Re: Williamson County Emergency Services Operations Center CM
Job No: 172201

Subj: Change Proposal No. 172201-0012

Re: Drainage Plan for Trenches Connecting Pier Caps

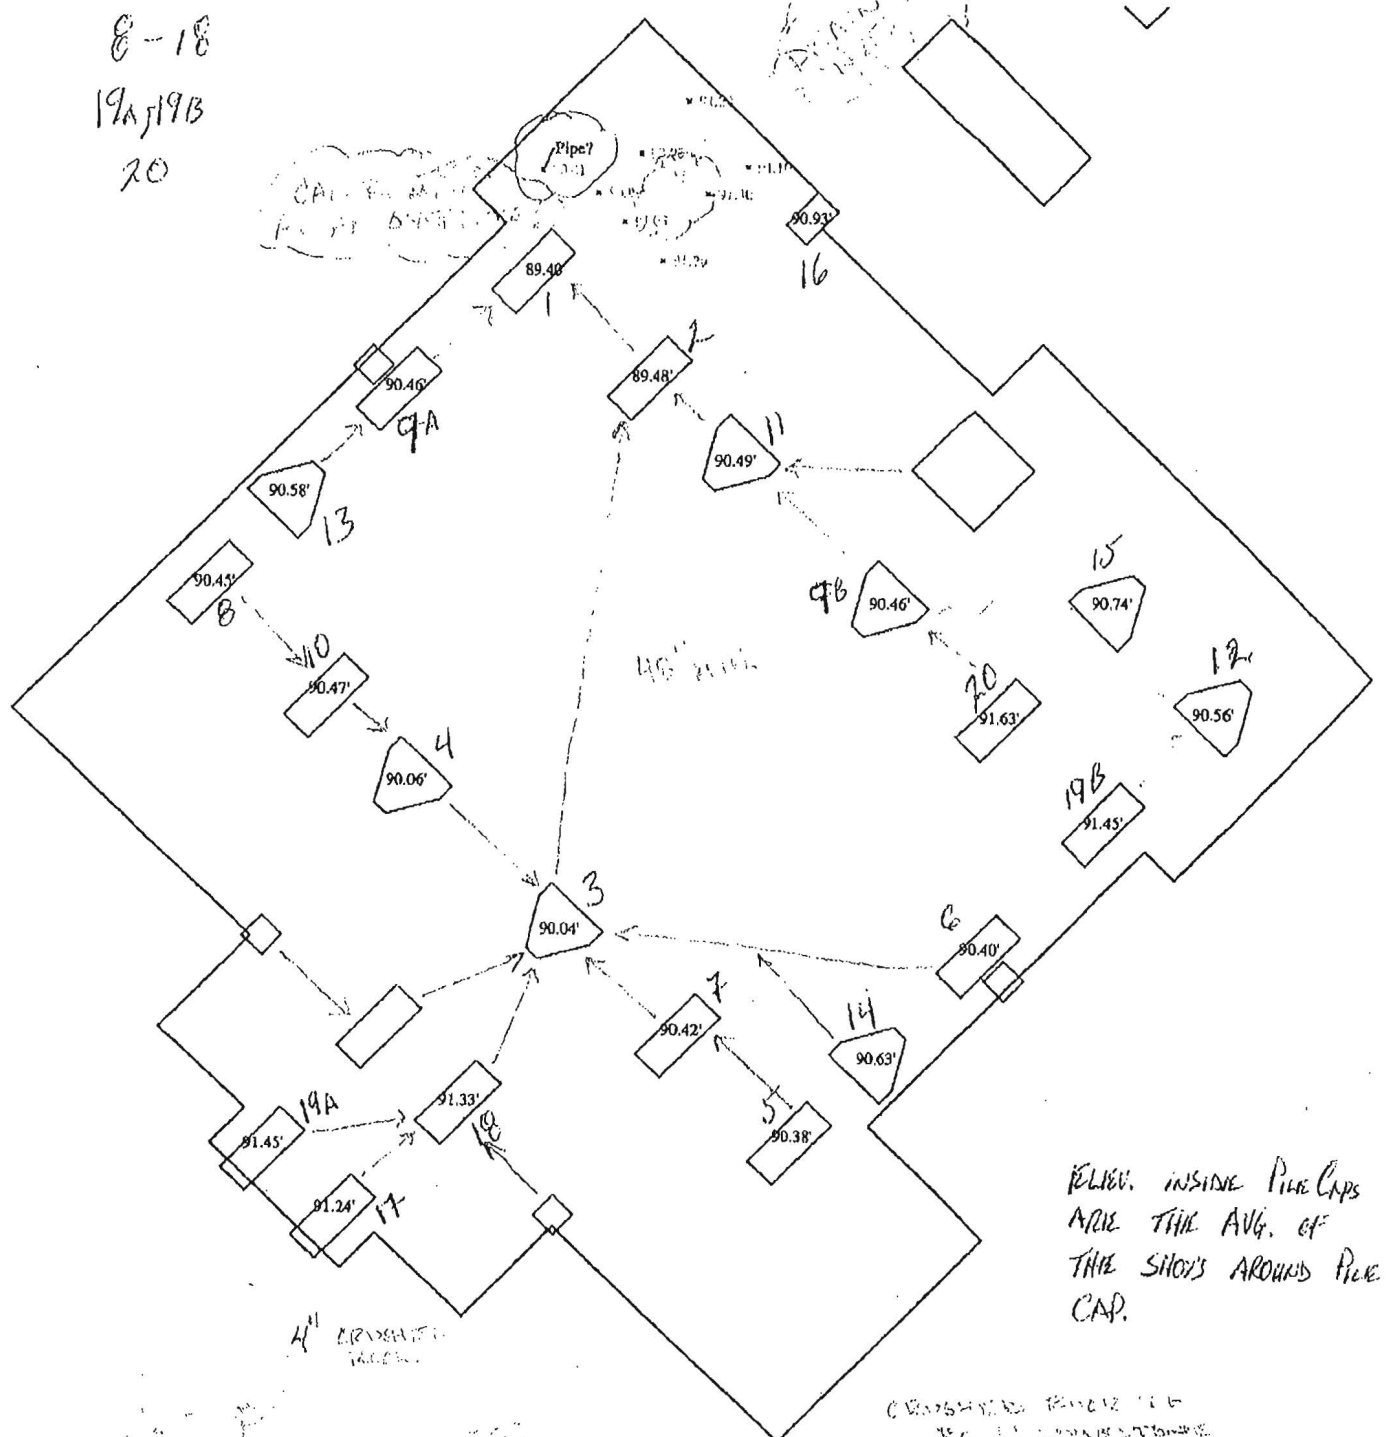
In reference to the response to RFI #042, dated 4/17/12, it has been previously mentioned that there are some concerns associated with water ponding under certain pier caps. To overcome the lack of drainage at these locations, a drainage trench system connecting the affected pier caps was proposed and accepted in RFI #042. Based on this information, it is our intent to install this drainage system based on the routing indicated in the attached drainage plan, provided by the Concrete contractor. As indicated in this plan, the pier caps will be connected by drainage trenches filled with gravel, and will be a minimum width of 24", except for the 48" section shown. This RFI is being sent for information purposes only, and it is our intent to proceed as indicated. However, if there are any issues or concerns associated with the proposed drainage system, please advise.

Please confirm the proposed solution and drainage plan to be acceptable.

*Proposed solution and drainage plan
is acceptable.*
